JULIA MORGAN
ARCHITECT
MERCHANTS EXCHANGE
SAN FRANCISCO

April 4, 1923.

Under separate cover I am mailing a re-
vised study of the Rose Garden area showing
a suggested treatment for the paths and pool.

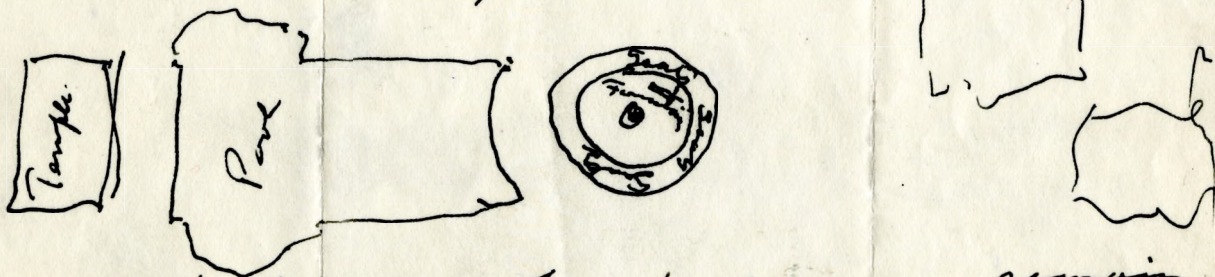
Regarding the pool I suggest that the fountain
be kept separate from the pool - maybe at a
higher level - and be surrounded by seats. From
these seats the houses can be seen on one side and
the pool and temple on the other. For example -
as shown in drawing.

There must be places where people can remain and
rest and look. The visitor should be able to sit down at
the best look out place. I think he should be able to see
the reflection of the temple in the pool or. Can agreeable to any better
arrangement. WRM
